DAVIS
PARTNERSHIP
ARCHITECTS

ADDENDUM NO: 03

Date Issued: December 9, 2015

**Re: Red Rocks Community College
Student Recreation Center**
Construction Documents, Dated November 9, 2015
Architect's Project No. 15803.00

S-507

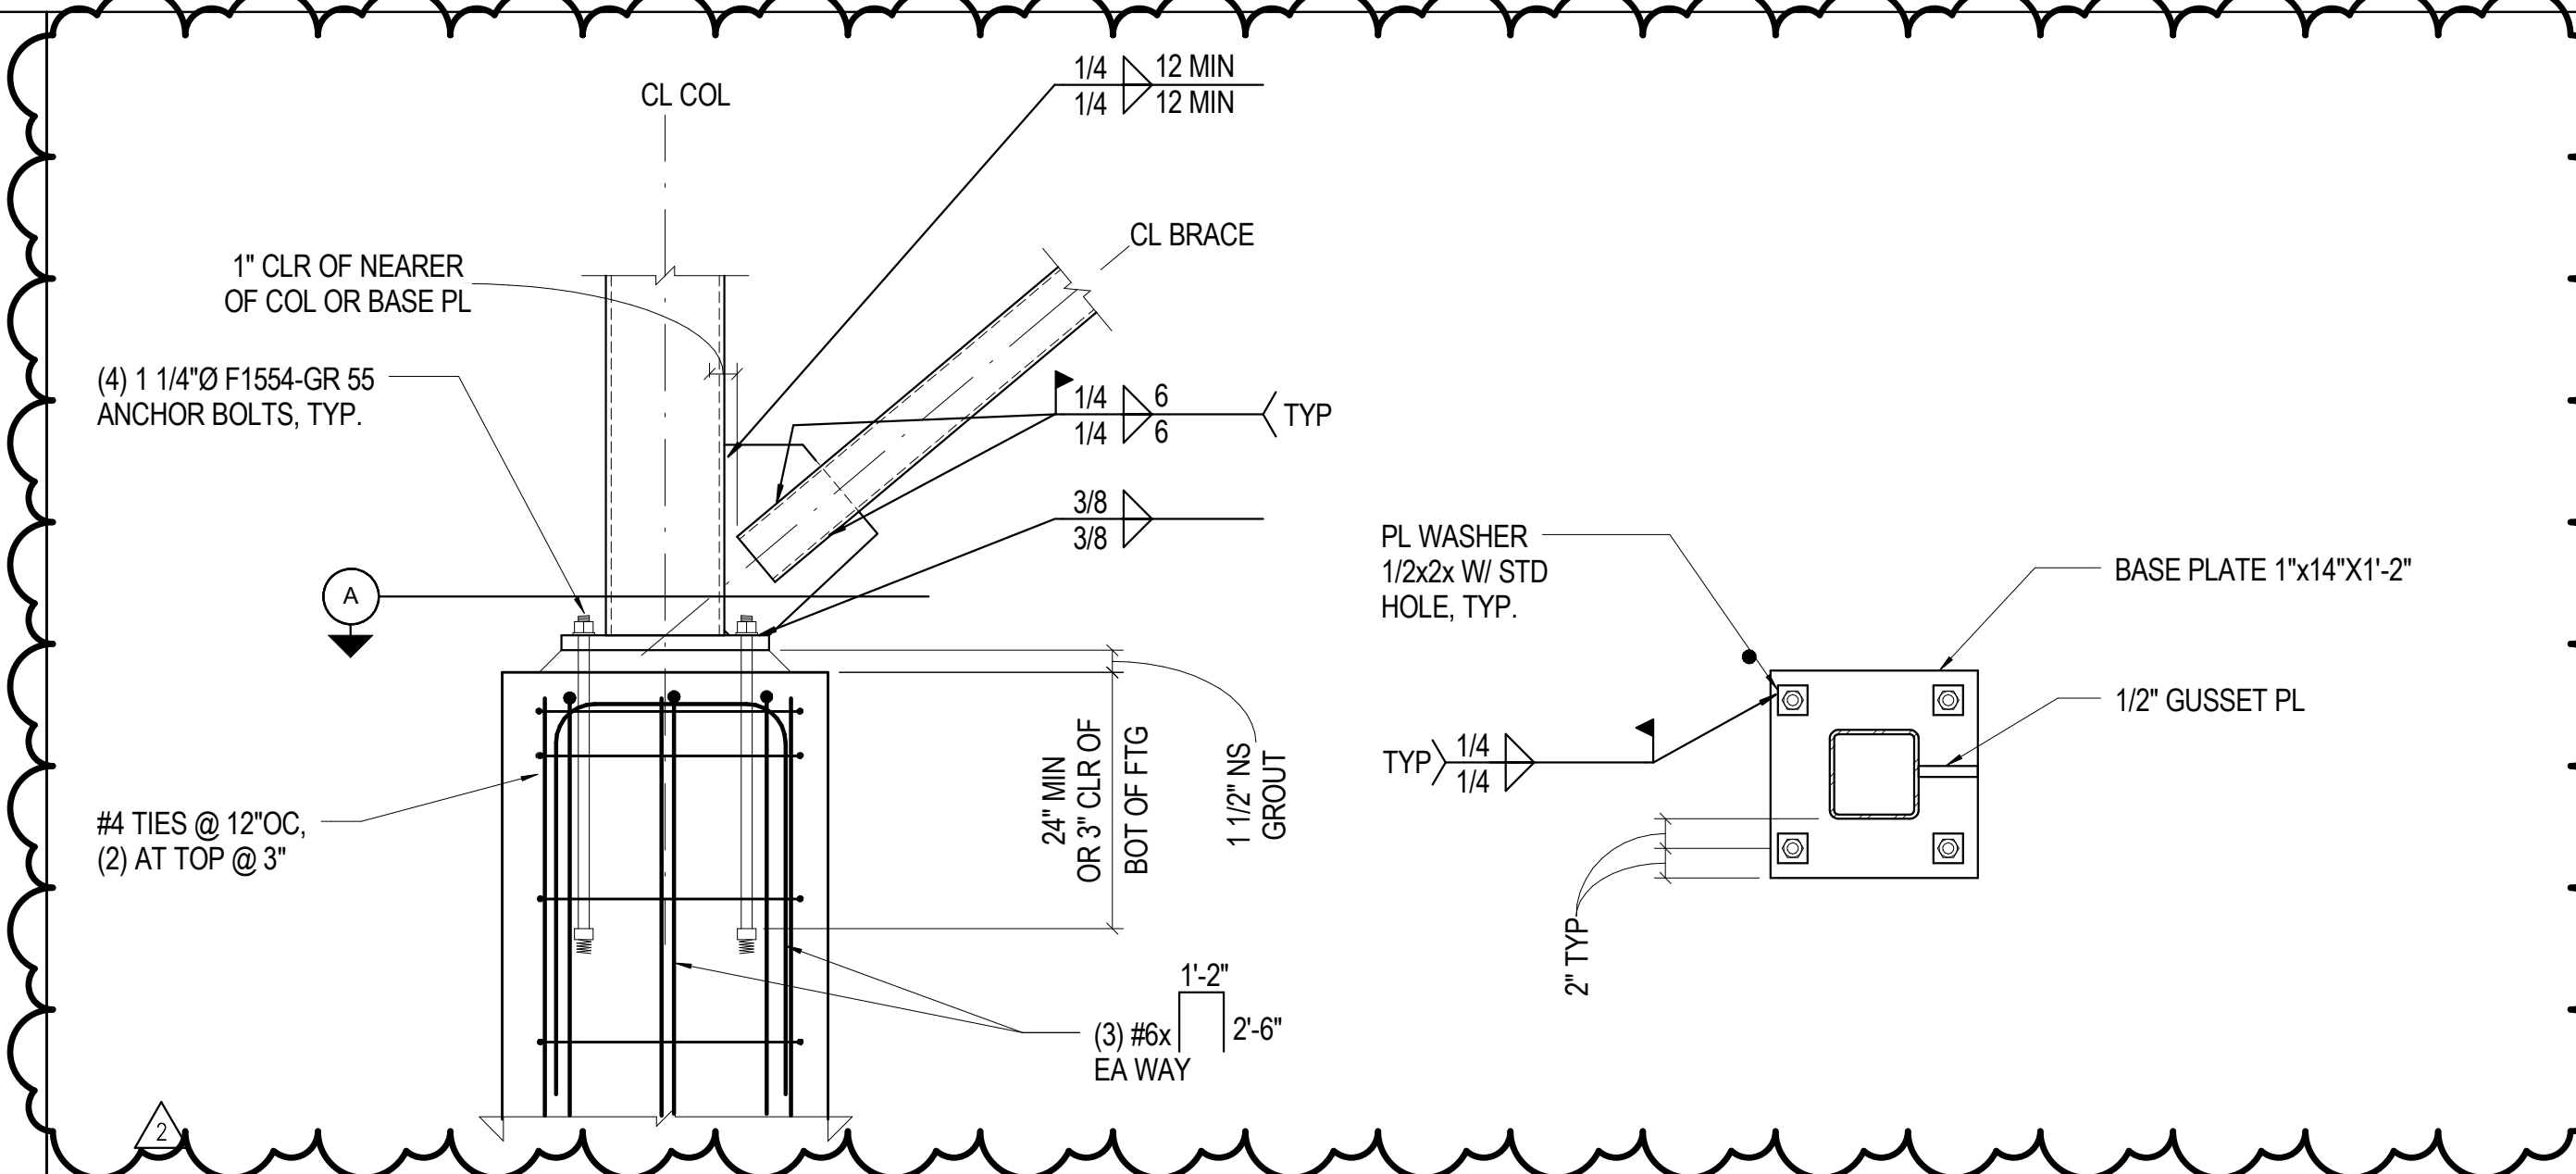
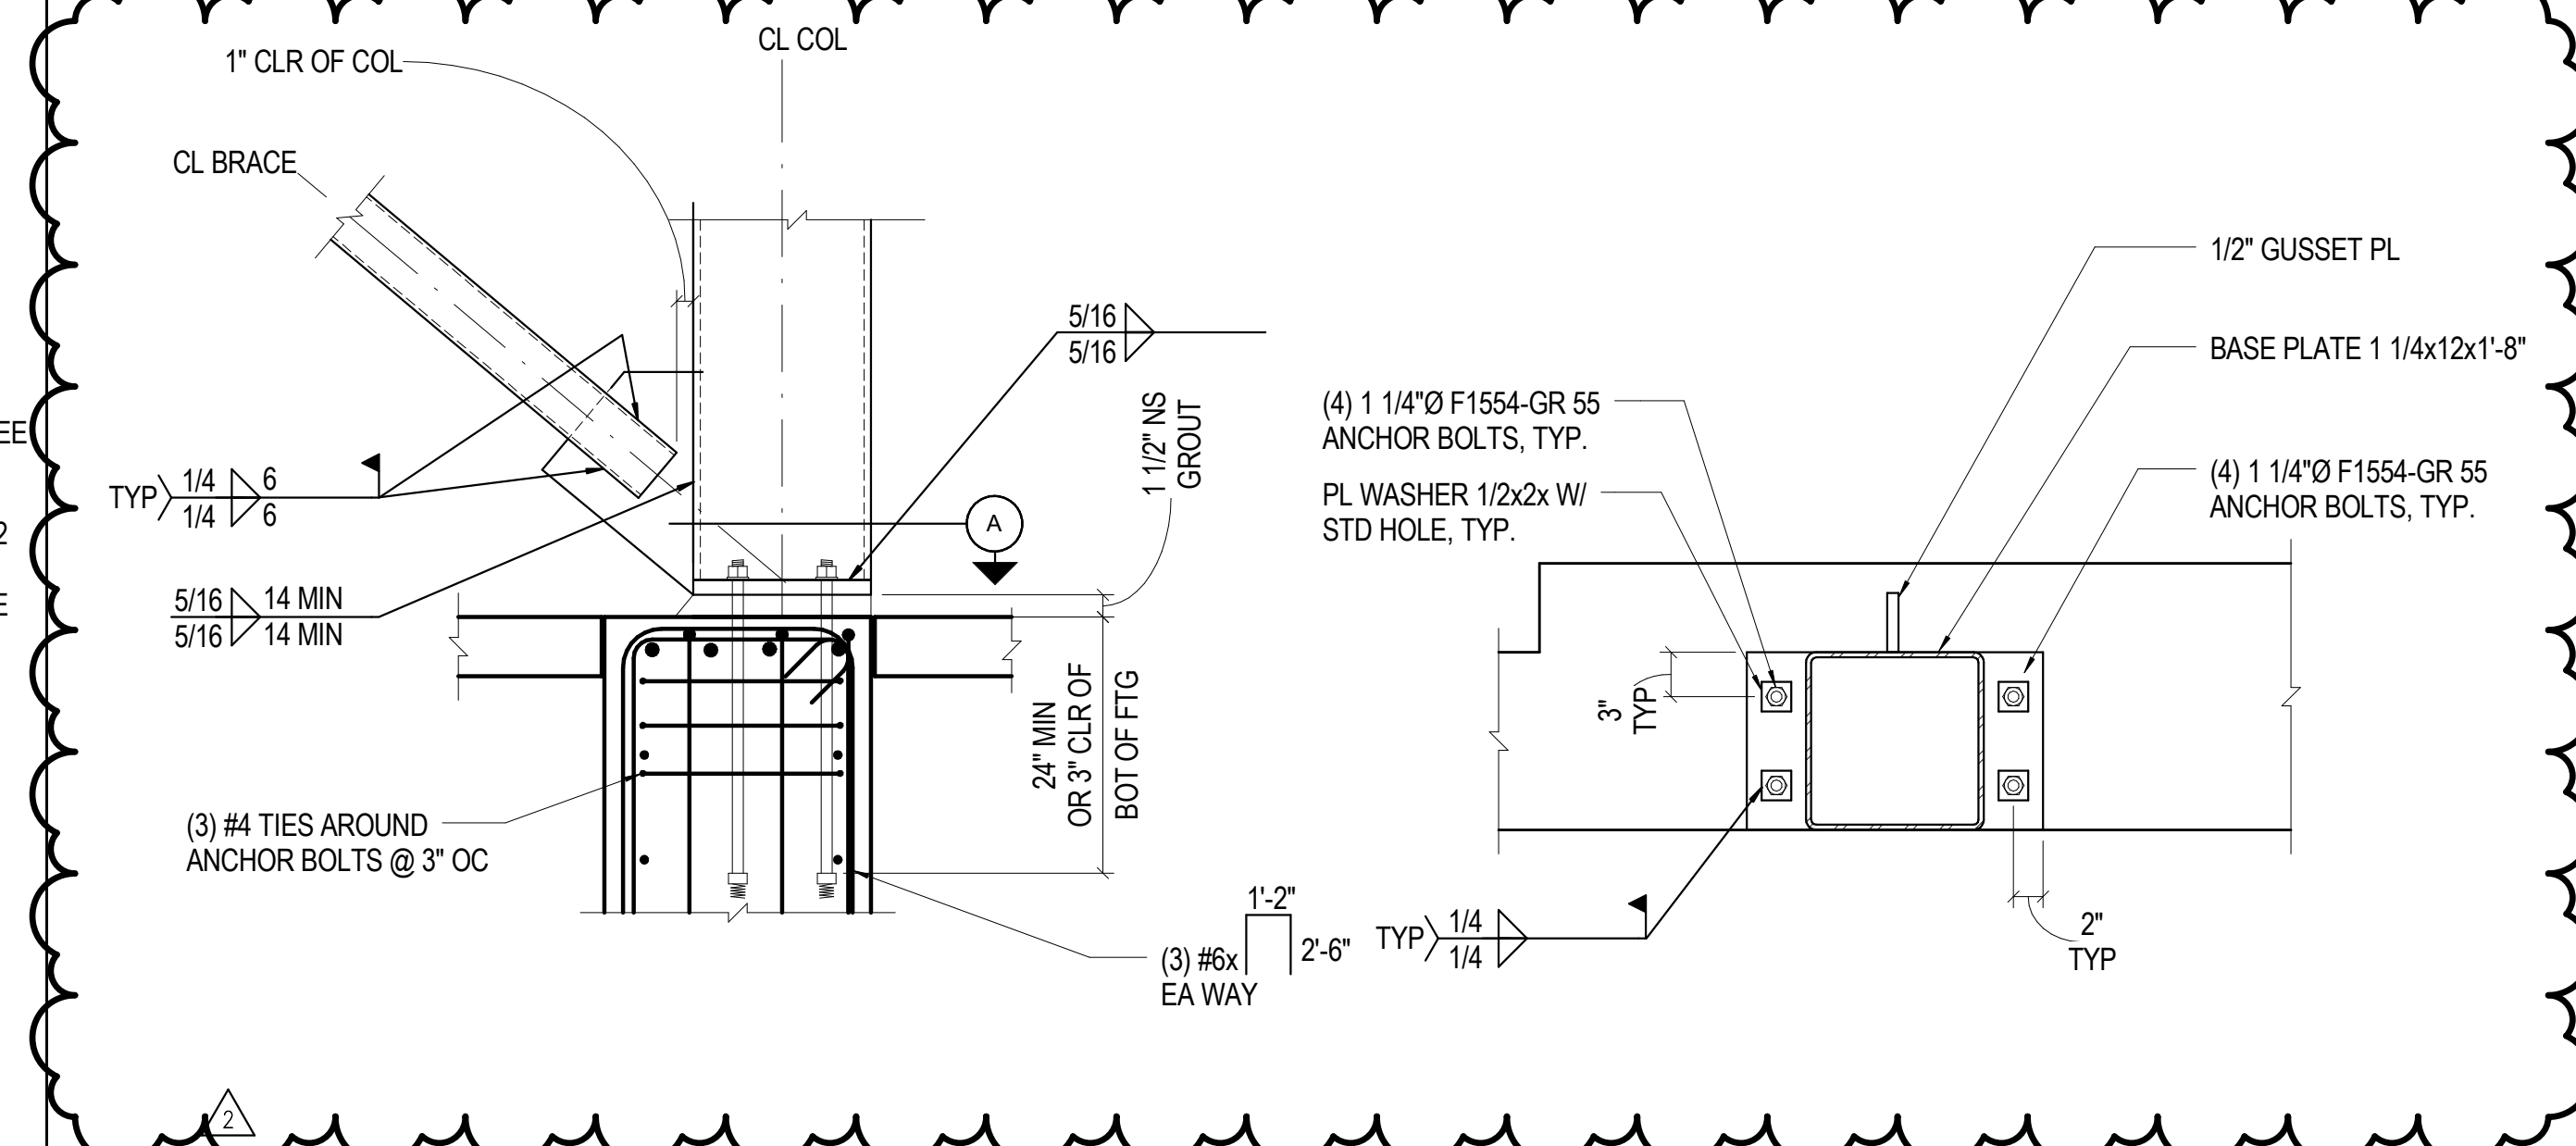
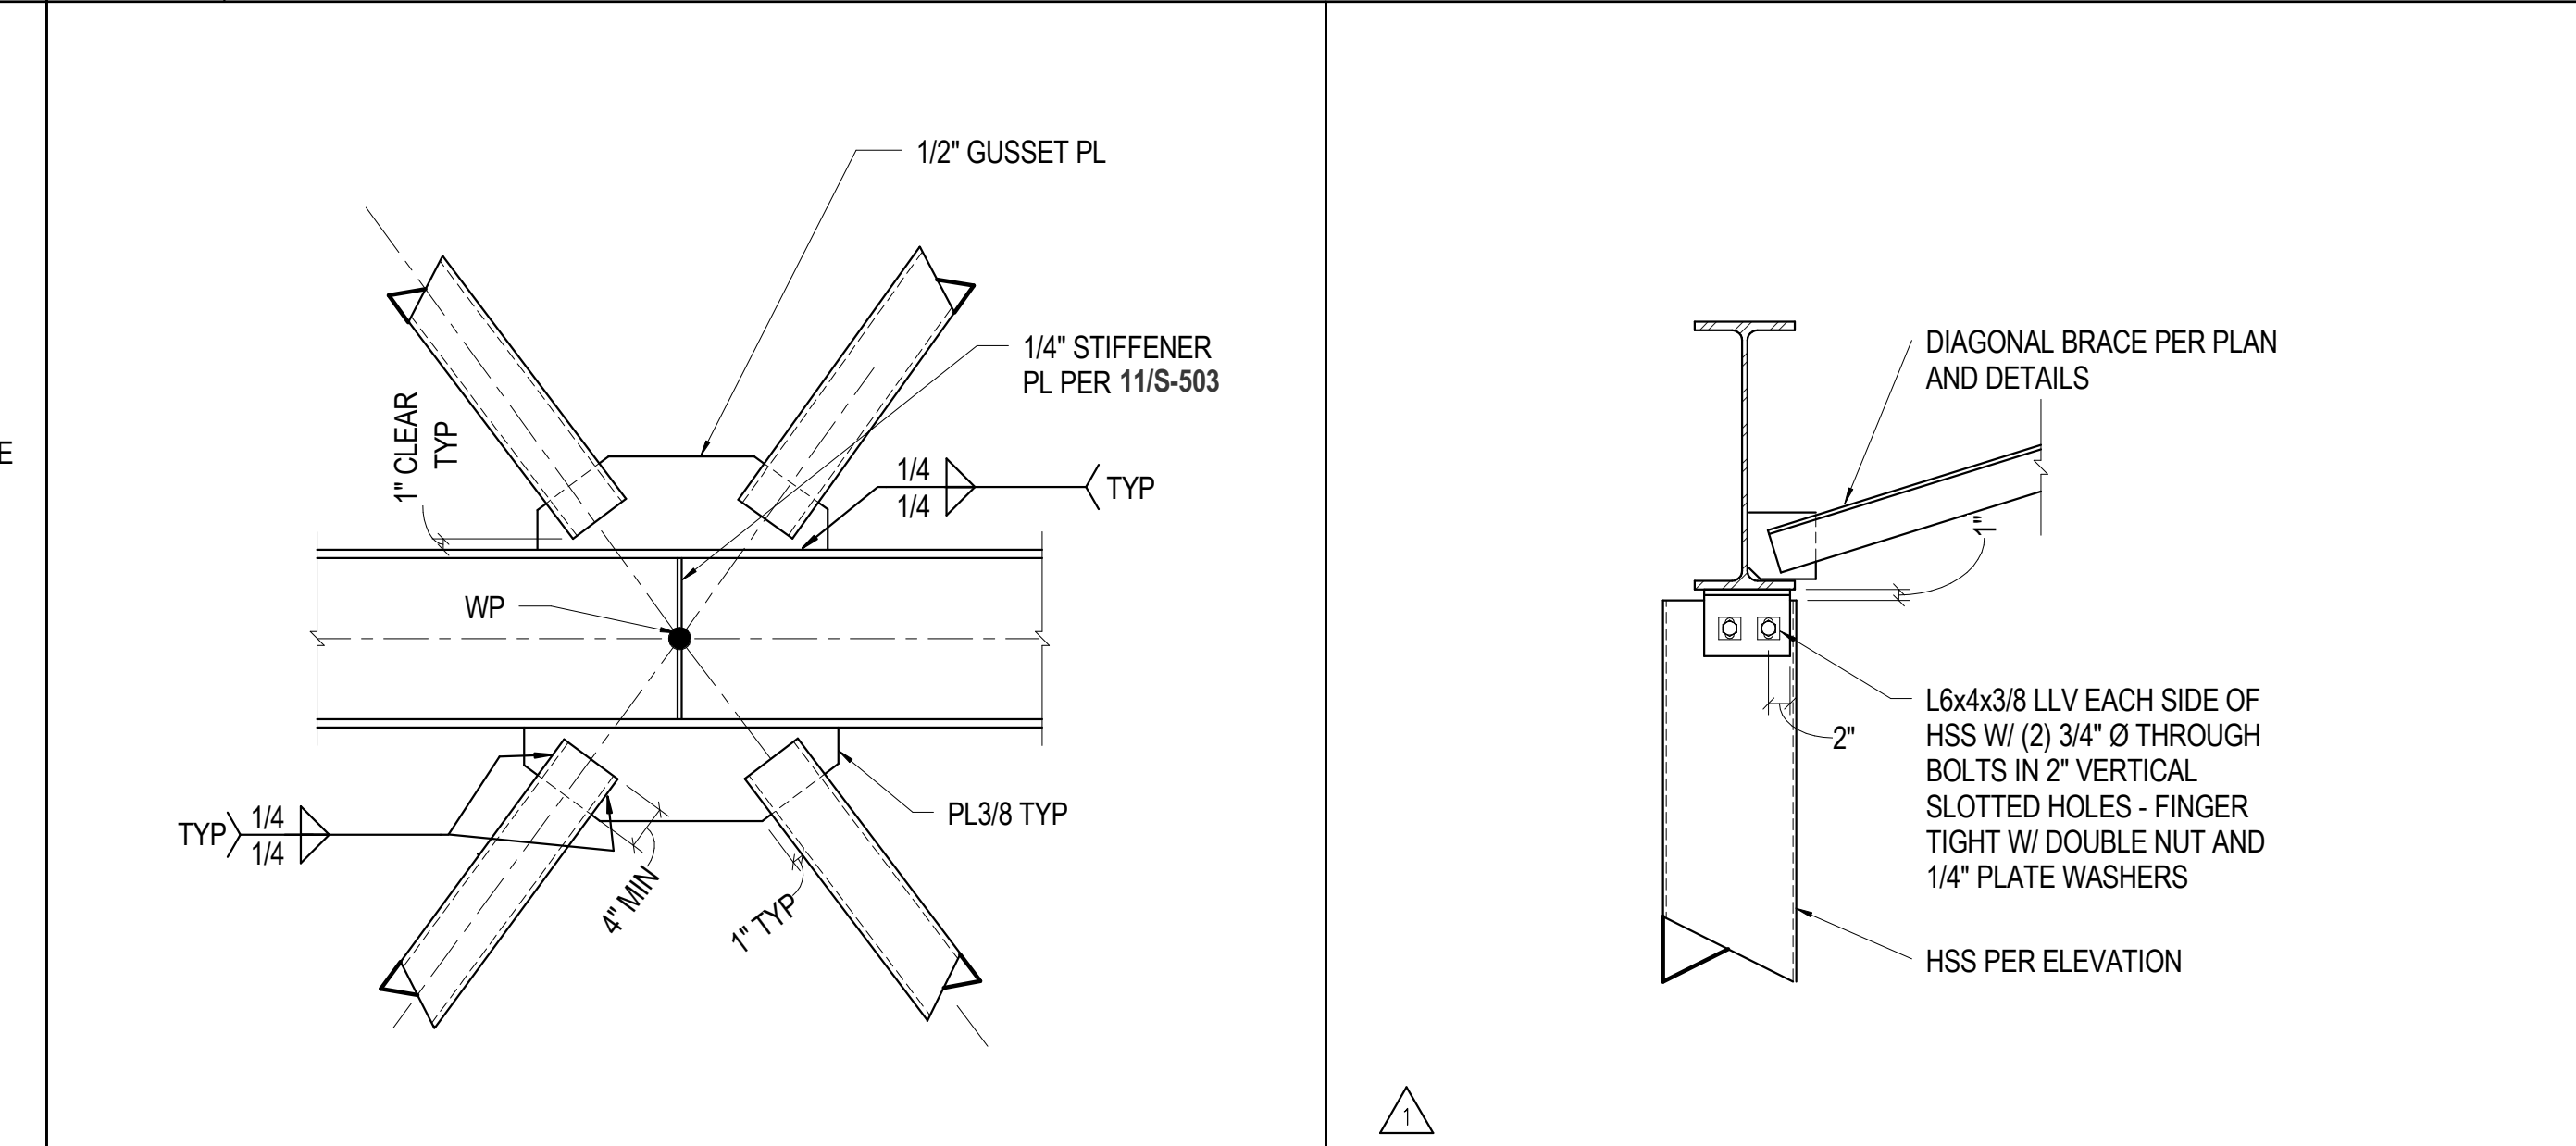
ADD. #3-70. Revised steel details:

1. 3/S-507: Removed dimension.
2. 8/S-507: Added detail reference for bottom flange connection.
3. 13/S-507: Revised detail.
4. 14/S-507: Revised detail.
5. 17/S-507: Added weld.
